HINCKLEY RAIL FREIGHT TERMINAL

Response to Secretary of State's Interim Decision and Tritax Responses

February 2025

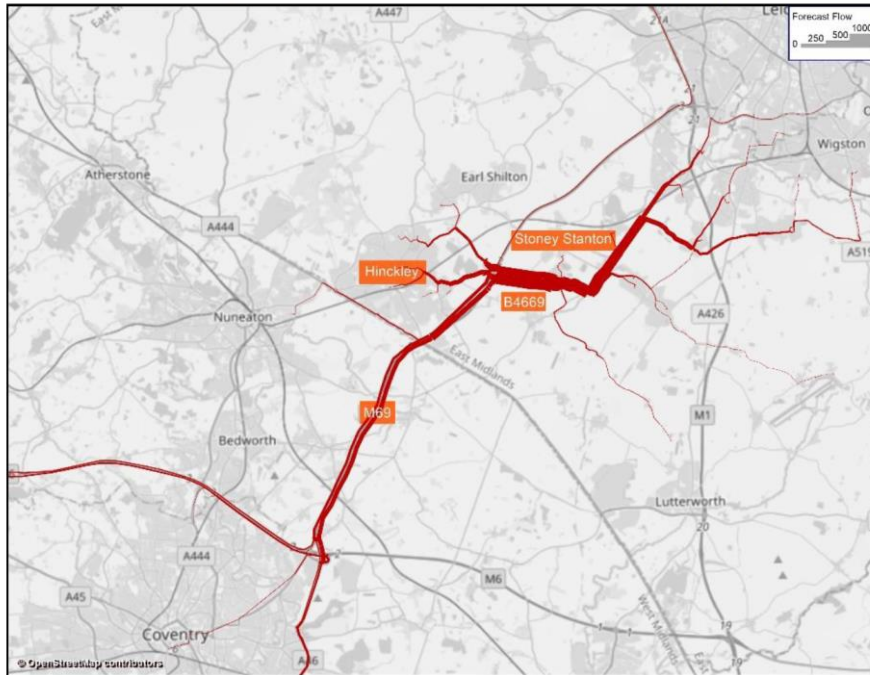
2.0.2 The B4669 route through Sapcote has several features which would make an increase in traffic very undesirable but a far greater concern is that the route would also be available to Heavy Goods Vehicles, including very large articulated lorries.

2.0.3 The route is clearly unsuitable for such large vehicles and the latest mitigation proposals would make matters far worse.

Figure 7.1 illustrates what various carriageway widths can accommodate. They are not necessarily recommendations.

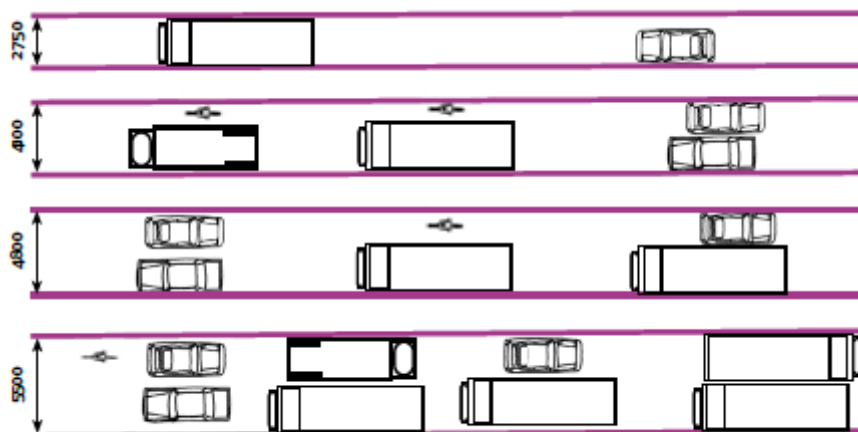
2.4.8 It is suggested by Tritax (based on Figure 7.1 of Manual for Streets, MfS) that this remains a suitable width for other vehicles to pass.

2.4.9 However, Tritax do not include the significant caveats to that diagram in MfS. Para 7.2.2 of MfS says:

2.4.11 In terms of width, we know an HGV can be 2.55 m wide and some SUVs over 2m wide. A Ford Transit van is 2.4 m wide. There is also the issue of wing mirrors. Fig 6.18 of Manual for Streets (also not quoted by Tritax) adds a further 0.25 for wing mirrors on either side, which creates a minimums width of at least 4.8m for two LGVs to pass if they touch mirrors together.

2.4.12 The 4.8 m width would simply not allow any vehicle to safely pass an HGV on that section of road, even at slow speed, without using the pavement.

Figure 6.18 Private and commercial motor-vehicles – typical dimensions.

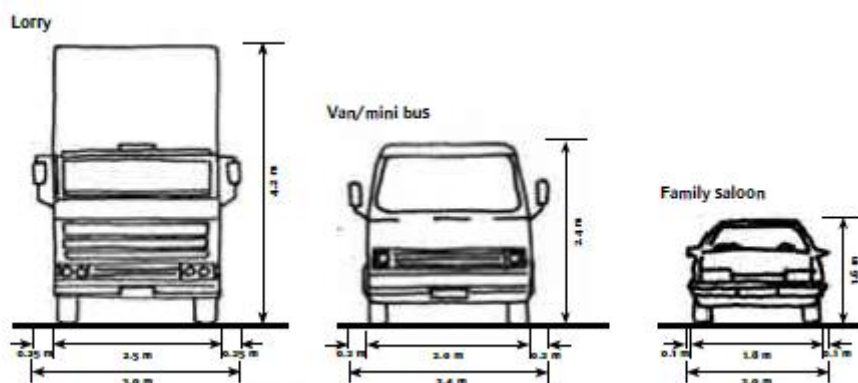
2.4.13 MfS also says these tolerances are appropriate for a speed limit of 20 mph. That is less than the 30 mph speed limit on the B4669. MfS also specifically excludes ‘short stretches of single lane working in two-way streets’, which is precisely what is envisaged by assuming HGVs will use the centre of the carriageway, to the exclusion of other vehicles.

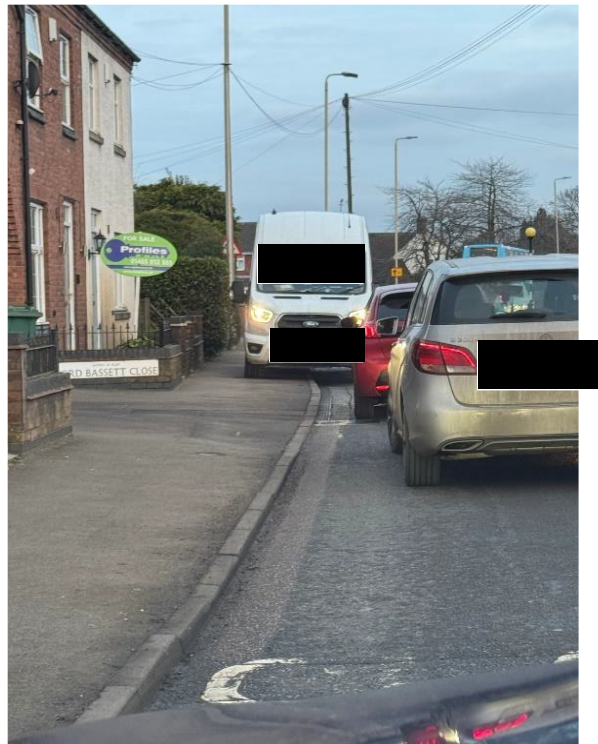
2.4.37 Because of the location of the Co-Op there is considerable activity around the junction which has only increased with the installation of a parcel collection point on the corner of the Co-Op (see photo below).

2.4.38 The Co-Op has five parking spaces, one of which is disabled. This means there is on-street parking commonly on both sides of Church Street (see photo below), and as noted by Tritax, some 150 per day illegally park in the bus parking area. This problem is further exacerbated by the limited parking on Church Street, where many properties do not have off-street parking

2.4.39 There seems to be an implicit assumption that this behaviour will stop once the scheme is in place but in reality the problem would most likely simply move to the edge of the new paved area, which would now extend further into Church Street narrowing the carriageway at that junction.

Figure 8: Strava Cycling Heatmap

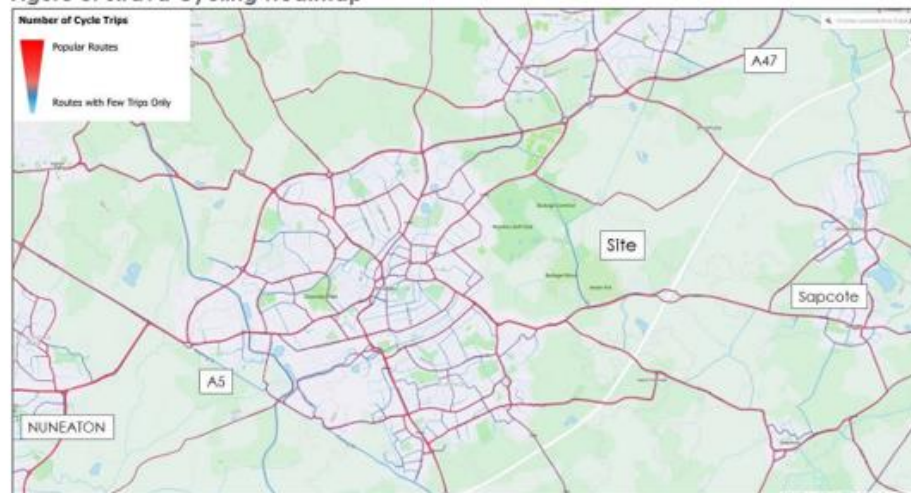
2.4.55 There is little consideration of cyclists, which we are told by Tritax average 20 per day, in the Technical Note. This again may mask higher numbers at the weekend and organised groups. The Strava Heatmap provided in the Sustainable
2.4.56 Transport Strategy (and quoted by Tritax elsewhere) has the route marked down as popular.
